RESPONSE TO SUBMISSIONS

Adaptive reuse of heritage listed dwelling to facilitate pre-school and primary school use including alterations and additions, on-site car parking, tree removal, landscaping and fencing

1 Rosemead Road
HORNSBY

REF: M200276
DATE: 11 November 2020

Figure 3. Plan of Option A

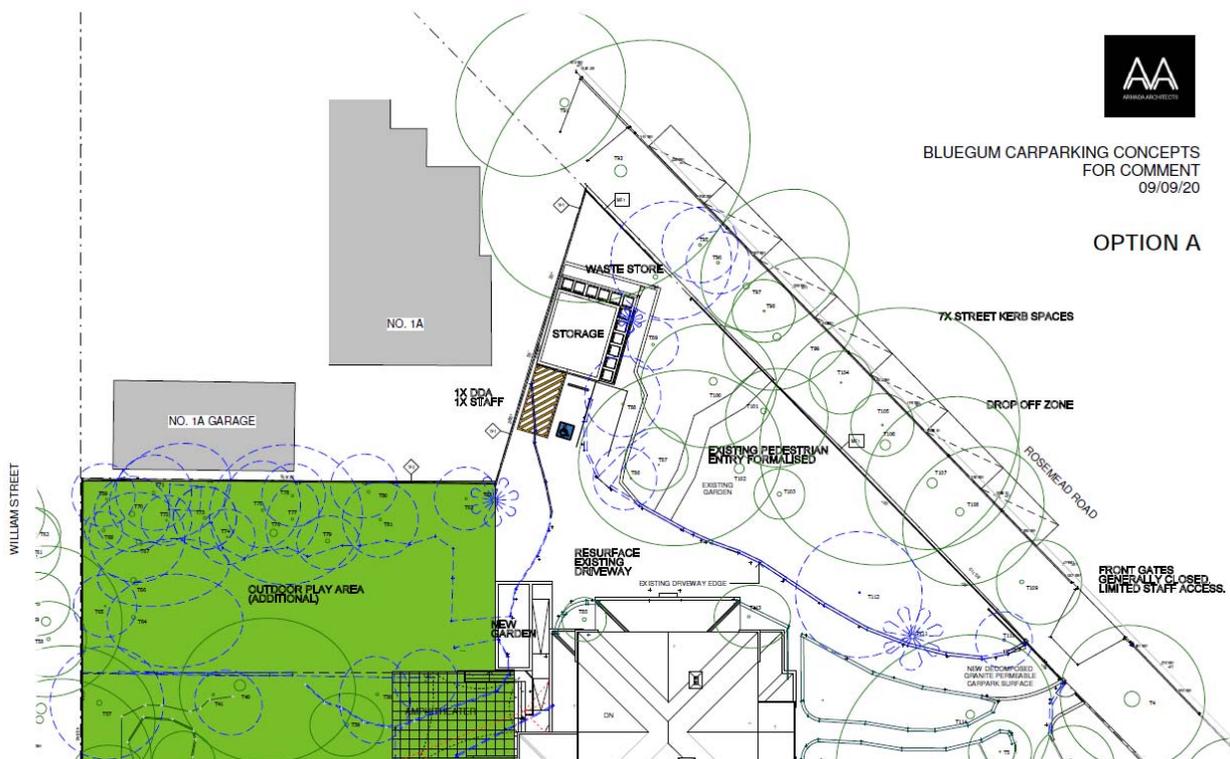
<i>Positives</i>	<i>Negatives / Other Considerations</i>
<ul style="list-style-type: none">• Important heritage elements retained:<ul style="list-style-type: none">- Existing driveway, without widening- Front gates, without widening- Significant Trees 111 (cabbage tree palm) and T112 (giant bird of paradise)• Increases garden area on the site• Reduces potential vehicle and pedestrian conflict with reduced vehicle movements on site• Removes car parking area from adjacent to 1A Rosemead Road• Trees in proposed car park area to the rear retained	<ul style="list-style-type: none">• Significant departure from DCP requirements to provide 12 car parks and a drop-off zone on-site• Council, DPIE and members of the public do not support a drop-off zone to Rosemead Road• As Council approval (Traffic Committee) is required for the street drop-off zone, this indicates an approval would not be achieved• Large number of public submissions raised concerns with parking and traffic impacts - a reduction in parking is likely to be seen as disregarding the concerns raised• Reduced car parking provision on-site relies on the site being highly accessible by public transport and via active transport modes (walking / cycling). Whilst the site is approximately 750m from Hornsby Station, use of public transport by parents would require a two-way walking trip of 1.5km and may not be a preferred option.• Existing narrow driveway does not meet standards and requires careful manoeuvring, continued use is likely to result in damage to fence posts / garden edging etc.• Front gates require replacement due to poor condition, therefore benefits of not widening are minimal

Figure 4. Plan of Option B

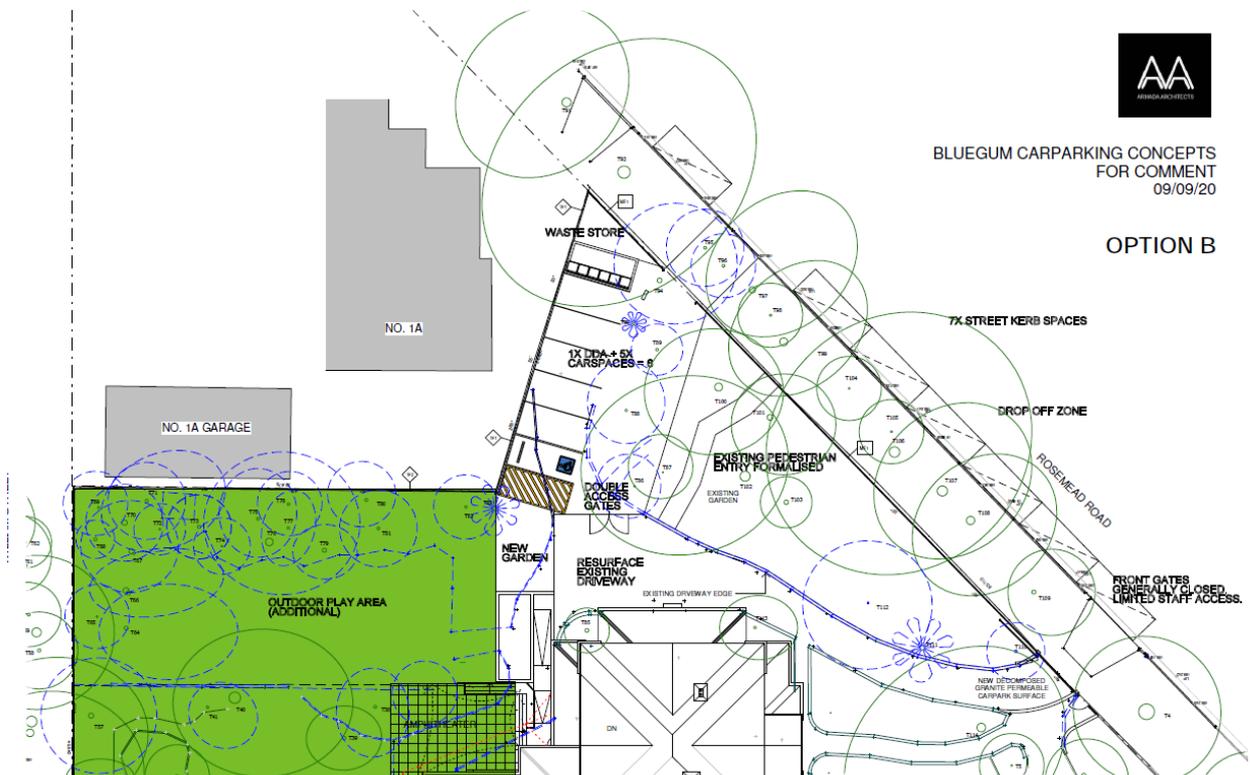
- More visual impact near the front of the site with car park visible from the street and reduced garden area to front
 - Requires removal of the garage which signifies the historical use of the site for a dwelling (noting it is not considered to be of particular heritage value)

- Introduces car parking adjacent to main dwelling of 1A Rosemead Road (noting that visual and acoustic privacy could be retained through fencing)
 - Retains trees in the 'tennis court' area, however this was purposely chosen as this area has the least significant trees (trees to be removed are of 'very low' or 'low' value)
-

Figure 5. Plan of Option C

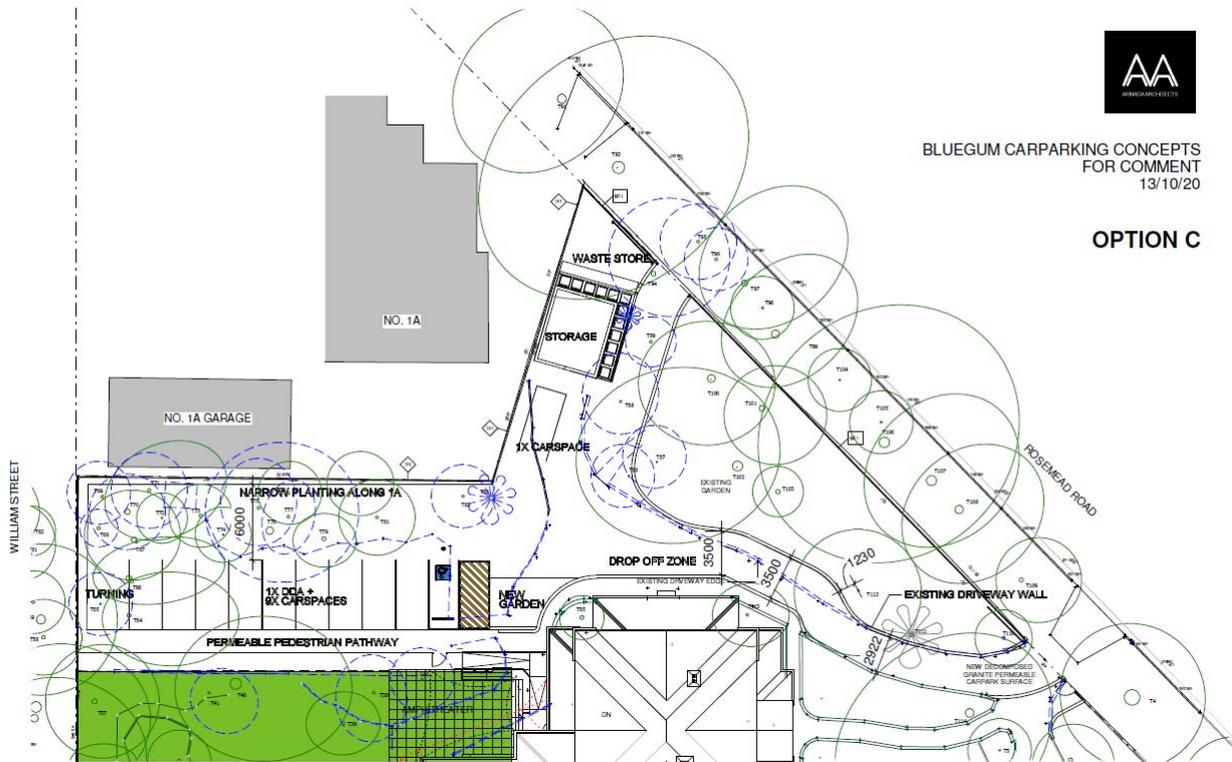
- Car parking remains at rear of site, layout flipped with parking bays away from property boundary
- Widening of existing driveway reduced in an effort to retain Tree T111 (as noted below, this has been found to not be achievable)

The proposed reduced driveway width in this option (noting the width of 2922mm on the above plan being less than the standard 3500mm), upon investigation, has proven not to be achievable on traffic grounds. Swept path analysis (shown in Figure 6) demonstrates that larger cars navigating the driveway would overhang the kerbs. As the “kerb” to the eastern side is a low brick wall this would not be possible. Whilst it is possible that the driveway may be able to be navigated with careful attention, it would likely result in damage to the garden edging and vehicles etc. and would likely discourage parents from using the driveway. Accordingly, widening of the driveway is necessary.

Figure 6. Swept path analysis for Option C

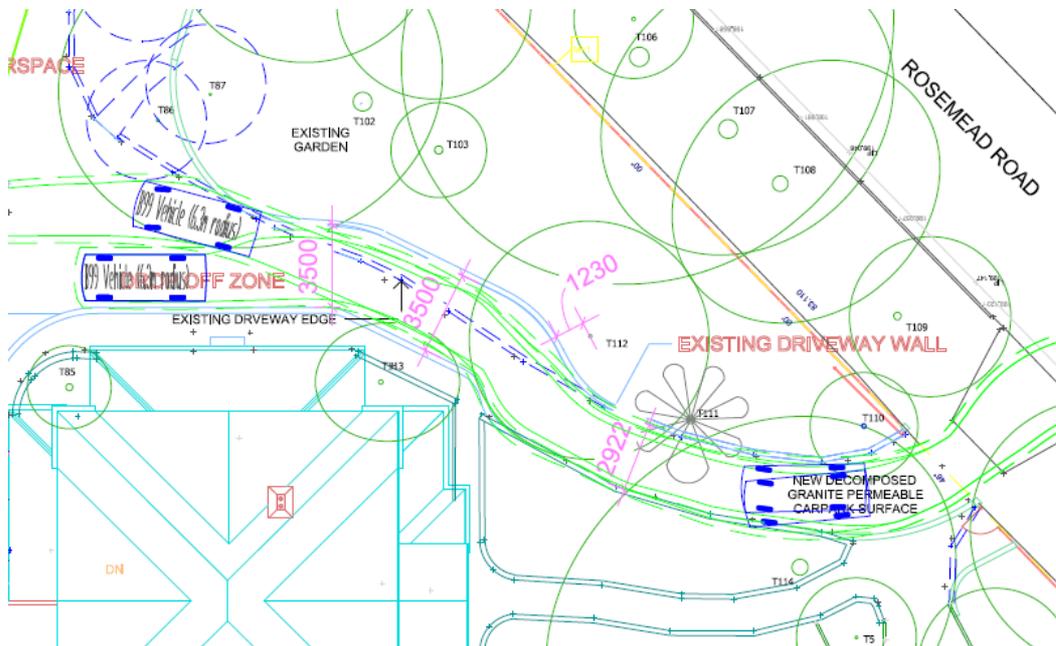
<i>Positives</i>	<i>Negatives / Other Considerations</i>
<ul style="list-style-type: none"> Provides parking spaces and drop-off area on-site as required by the DCP Flipping the car park moves car parking bays away from 1A Rosemead Road boundary and further reduces potential acoustic impacts Car parking area is located at the rear of the site where not visible from the street frontage thus minimising heritage impact from the street, also impacts trees of least significance classified as 'very low' or 'low' value 	<ul style="list-style-type: none"> The retention of the narrower existing driveway width proposed alongside T111 is not workable – this plan does not achieve what it sets out to (i.e. retain T111) Two high value trees near front of the site still require removal (T111 and T112) with this option
